CELMV-ED-3P (CELMV-ED-3P/15 May 90) (1110-2-1150a) 2d Ed  
Mr. Statts/aa/2614  
SUBJECT: Lake Pontchartrain, Louisiana and Vicinity, High Level  
Plan, Design Memorandum No. 20 - General Design, 17th Street  
Outfall Canal

SUBJECT: Lake Pontchartrain, Louisiana and Vicinity, High Level Plan, Design Memorandum No. 20 - General Design, 17th Street Outfall Canal

SUBJECT: Sheet Pile Wall Design Criteria

Figure 21. Schematic of slope in pile and movements at pile tip due to movements in the foundation

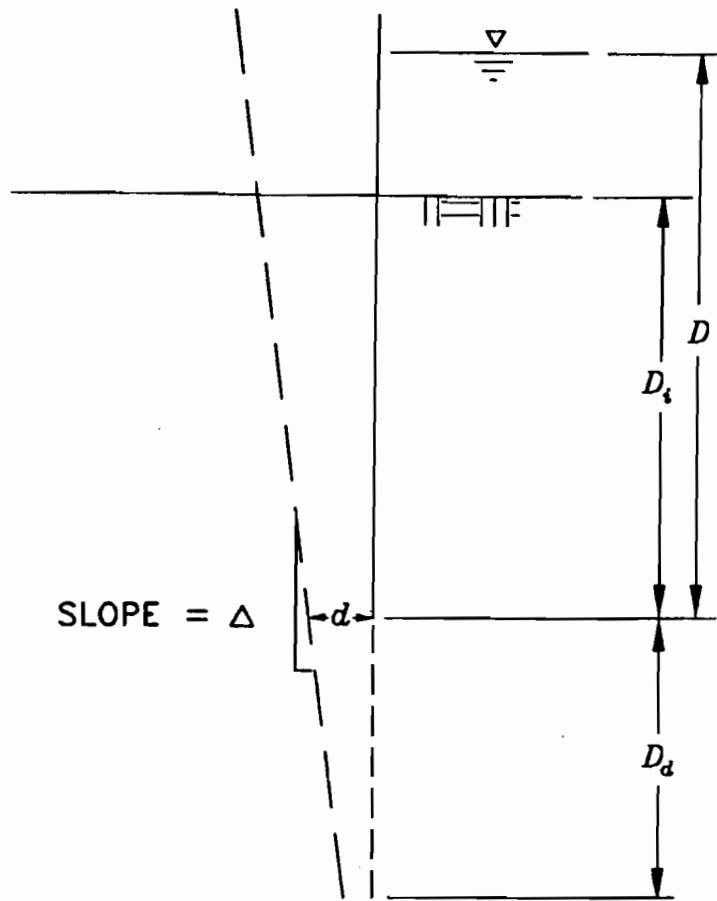
61. The procedure amounts to adding a "correction" to the displacement computed by CANWAL. First, the embedment and displacement corresponding to a safety factor of 1.0 are computed by CANWAL. The computed embedment depth is  $D_i$  and the total length of pile is  $D$  as shown in Figure 21. As discussed above, this displacement corresponds to the correct moment distribution. Second, the additional embedment depth  $D_d$  needed to obtain the required safety factor is computed using CANWAL. Next the appropriate plots in Figures 22 to 25 are used to determine the displacement and slope at the pile tip. The displacement at the top of the pile is thus the sum of the CANWAL displacement and the quantity  $d + (\Delta \times D)$ .
